**NSLPP MEETING HELD ON 07/08/2024**  
**SECTION 4.55 APPLICATION REPORT**

**ADDRESS/WARD:**                    2 Folly Point, Cammeray (S)

**APPLICATION NO:**                DA 397/19/3

**PROPOSAL:**                        S4.55(1A) modification application for internal and external alterations to existing dwelling house and davit (boat lift) structure.

**Figure 1. Proposed Roof Terrace Plan**

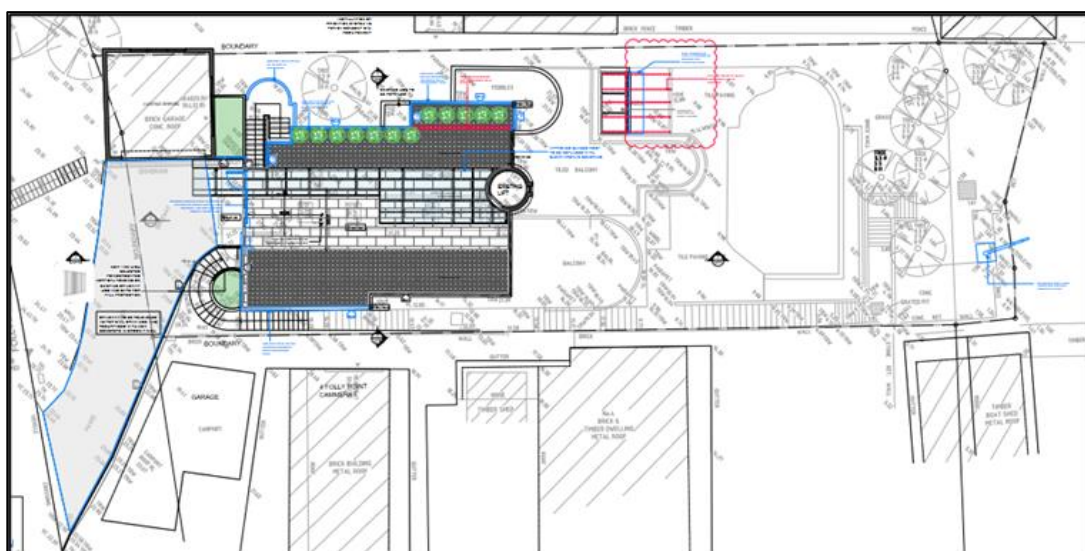
1. Low wall raised to a height of 1 metre to act as a balustrade at the north western and along the western and south eastern elevations;
2. Existing planter box and associated balustrading at the north western corner to be removed;
3. Approved angled driveway gate changed to vertical lattice metal fence (no change to the approved 1.8 metre height, as per Condition 11) with finish changed from silver to white powder coated finish;
4. New vertical lattice metal fencing along northern edge of driveway;
5. Change to Canopy roof material from glass to clear acrylic;

The proposed modifications to the existing roof level are unlikely to create significant additional privacy impacts when compared to existing. The proposed removal of the planter box in the north-western corner of the roof level is to an area that is not proposed to be easily accessible or in use as an outdoor living space. The previously approved pebbles for the majority of roof areas will be unchanged in this proposal and will ensure that these spaces are clearly demarcated from the access pathways and will restrict any easy use of these spaces other than for maintenance.

PROJECT NUMBER	P101	PROJECT ADDRESS	2 FOLLY POINT CAMMERAY	
DRAWING NUMBER	A211	DRAWING TITLE	PROPOSED LEVEL 5	
SCALE	1:100	PAPER SIZE	A3	REVISION
DRAWN BY	RN	REVIEWED BY	NK	PROJECT STATUS
				S4.55

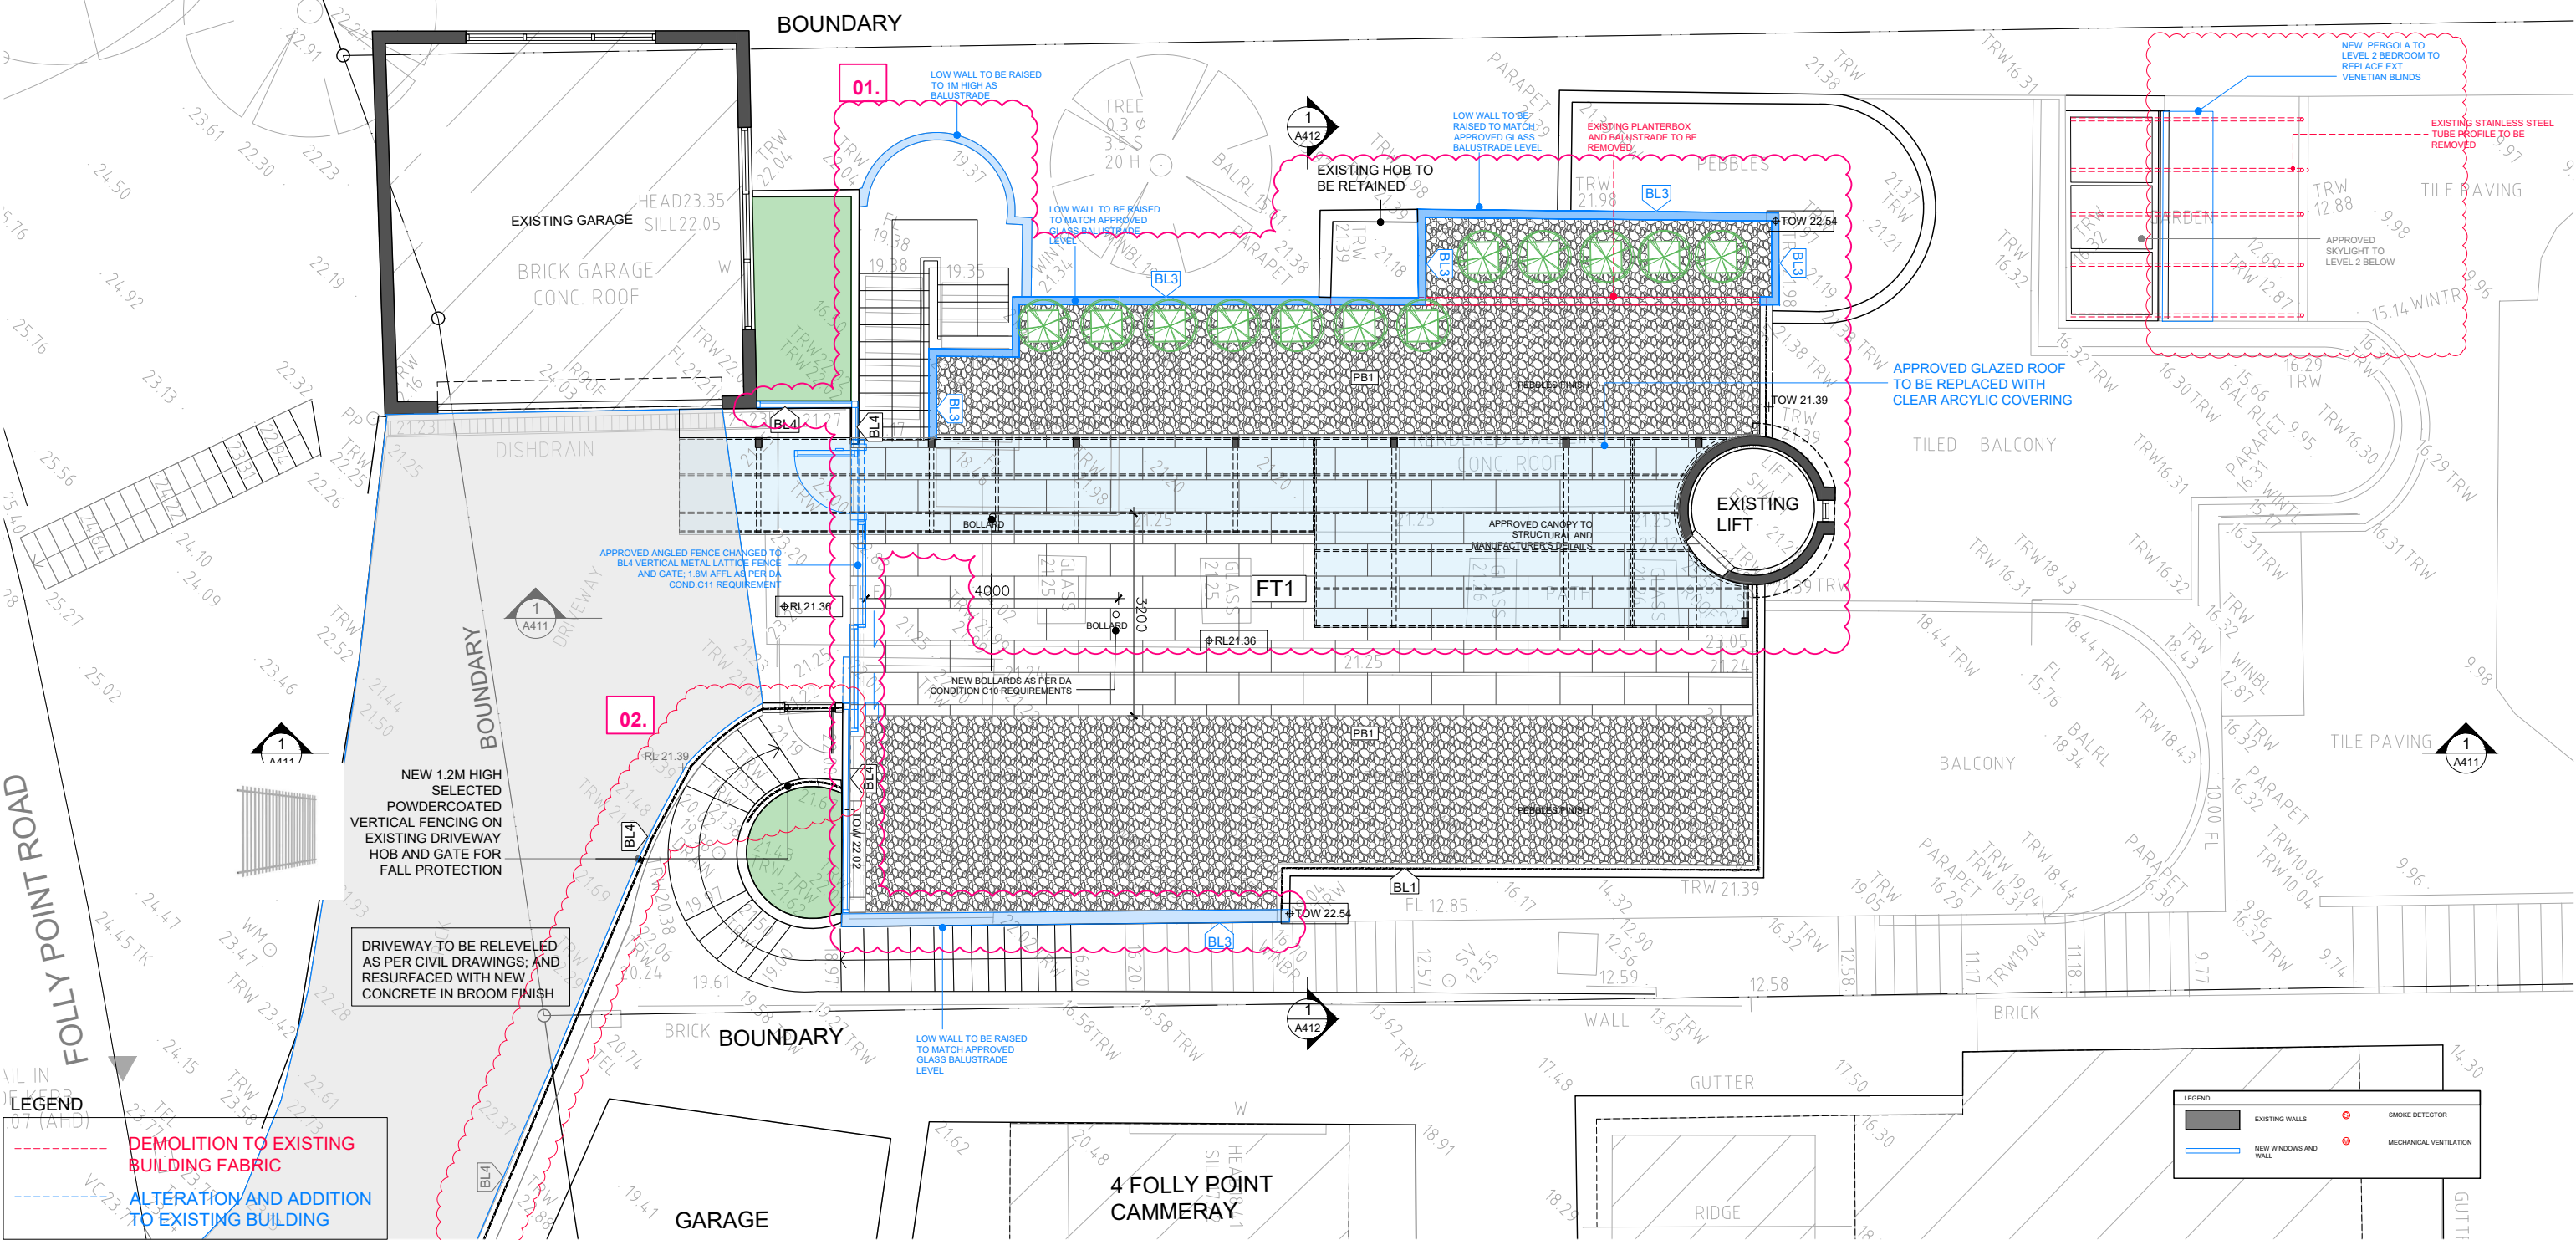
The application was notified in accordance with Council's Community Engagement Protocol, and one submission was received raising concern about the potential usability of the Level 5 roof area. The original large-sized pebbles and limited trafficability of the roof level as approved under DA 397/19 remain unchanged and the proposed modifications will not have any additional impact upon the usability of the roof level that would create additional privacy impacts.

- PROPOSED LIST OF CHANGES**
- GENERAL**
- BALUSTRADE CHANGES TO LEVEL 5 AND 4; ROOF CANOPY MATERIAL CHANGE
  - NEW VERTICAL FENCING TO DRIVEWAY AND STAIRS; ENTRY FENCE AND GATE CHANGES
  - INTERNAL LAYOUT CHANGES
  - BALUSTRADE BL2 AMENDMENTS
  - EXISTING S/S TUBES TO BE REMOVED OVER L2 BALCONY
  - NEW PERGOLA TO WINDOWS
  - ALTERATION AND ADDITION OF EXTERNAL WINDOWS AND EXHAUSTS
  - CONVERT EXISTING NON-ACCESSIBLE LILYPOND TO BECOME BALCONY
  - GROUND FLOOR GLASS POOL FENCE RECONFIGURED
  - NEW SIDE FIXED GLASS BALUSTRADE ADDED TO SIDE OF POOL AND SIDE WALK
  - DAVIT RELOCATED TO NEW LOCATION

INSTALLATION OF IRRIGATION SYSTEM AS PER DA CONSENT C13. REQUIREMENT

C13. An automated irrigation system is to be installed on the roof level to irrigate the approved landscaping shown on drawing A211, Revision B, drawn by Play Co Pty Ltd, dated 10 May 2024, and received by Council on 22 May 2024.

G1. The landscaping shown in the Level 5 Plan numbered A211, Revision B, prepared by Play Co Pty Ltd, dated 10 May 2024, and received by Council on 22 May 2024, must be completed prior to the issue of any Occupation Certificate.

PROJECT NUMBER	P101	PROJECT ADDRESS	2 FOLLY POINT CAMMERAY	
DRAWING NUMBER	A710	DRAWING TITLE	DAVIT DRAWING	
SCALE	1:50	PAPER SIZE	A3	REVISION
DRAWN BY	RN	REVIEWED BY	NK	PROJECT STATUS
				S4.55

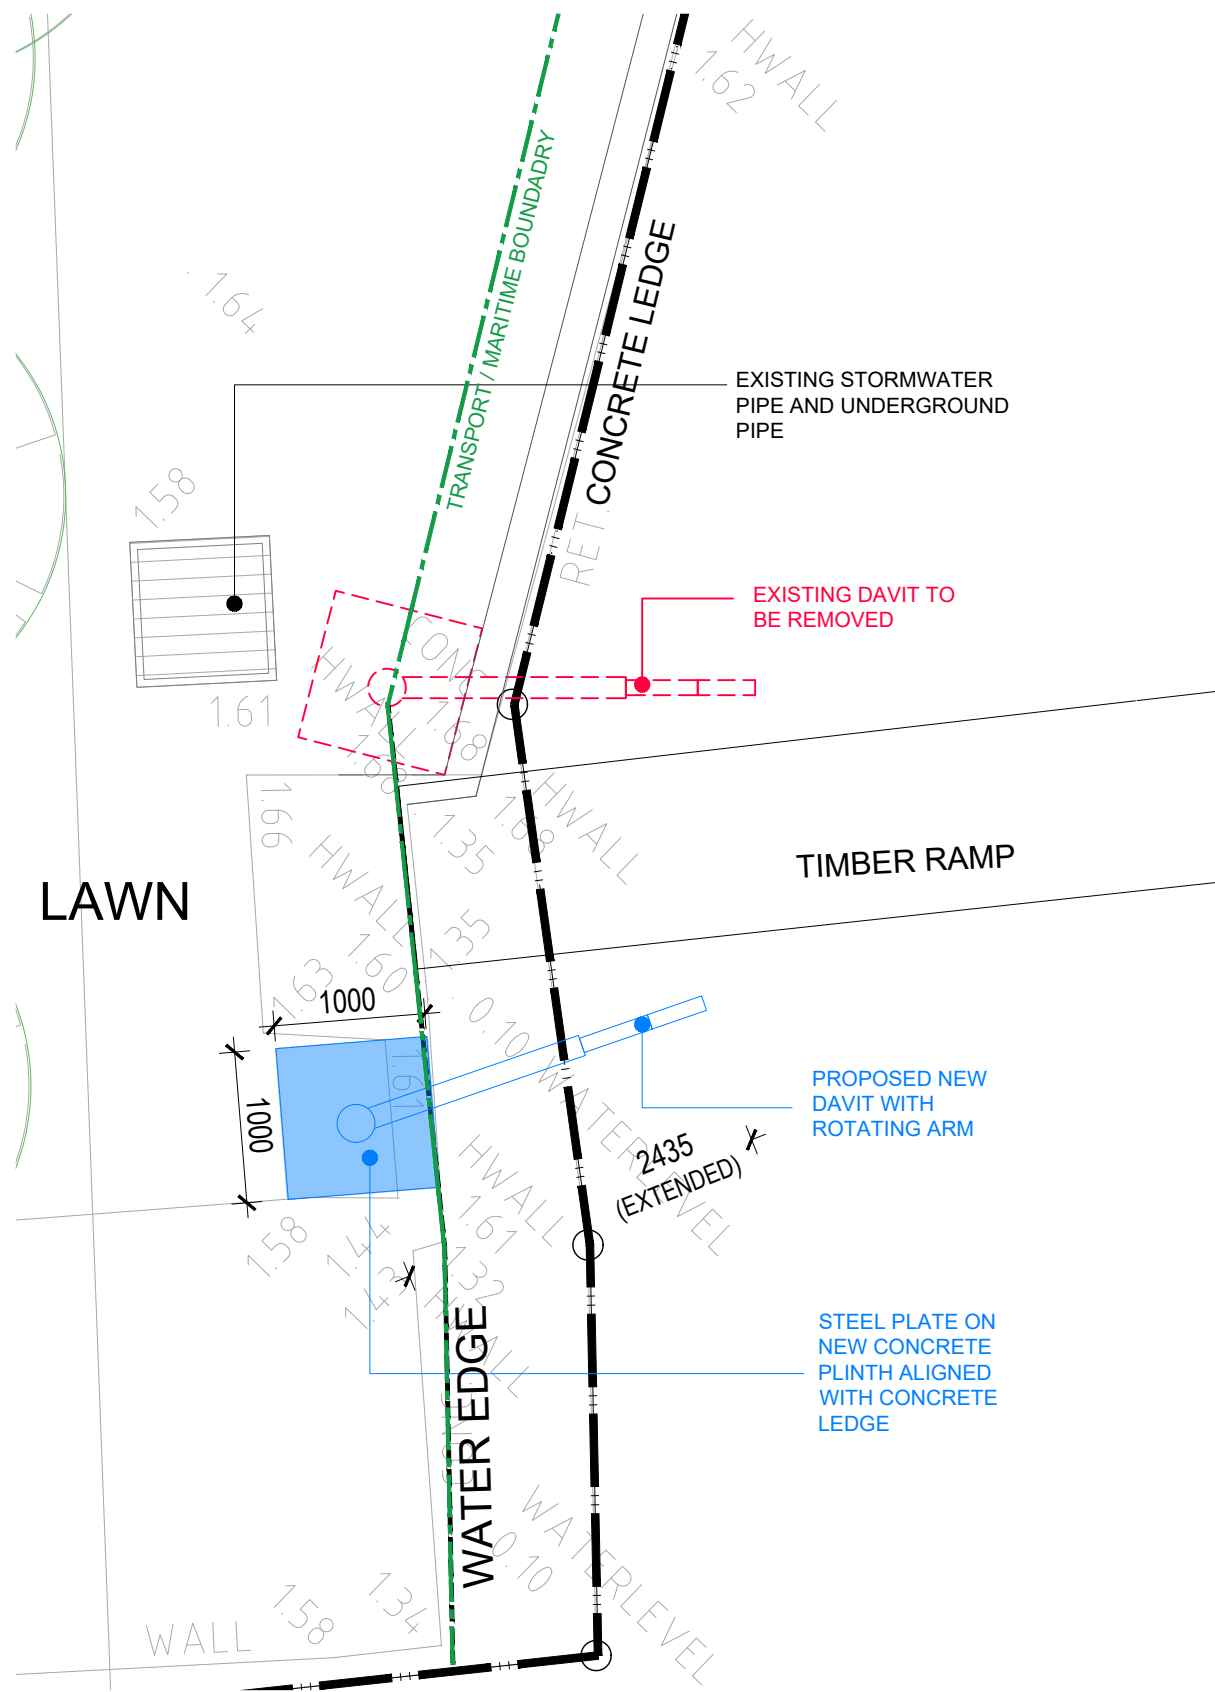
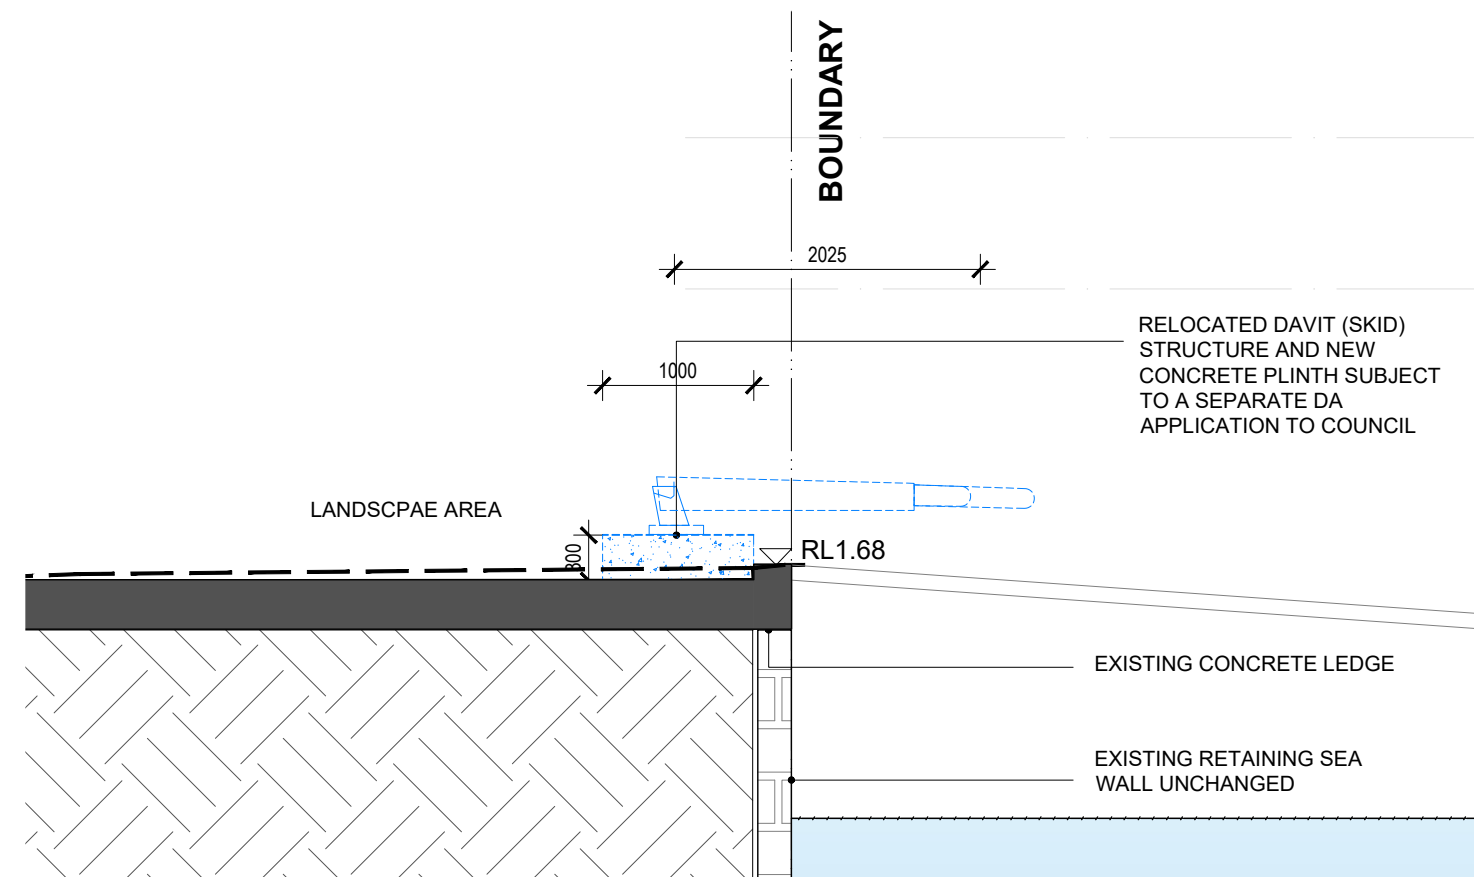
23. Removal of existing davit structure and replacement with new davit contained wholly within the site.

While a portion of the site lies within the foreshore building line area, the majority of the proposed works are located outside this area. The only elements within the foreshore building line are the new fixed glass balustrades added to the sides of the pool area on Level 1, and the replacement of the existing davit on the existing seawall with a new davit further east. These works are very minor, with no significant excavation or additional bulk and scale, and are not considered to have an adverse impact upon the waterway, flora, and fauna or the heritage and environmental significance of the surrounding area.
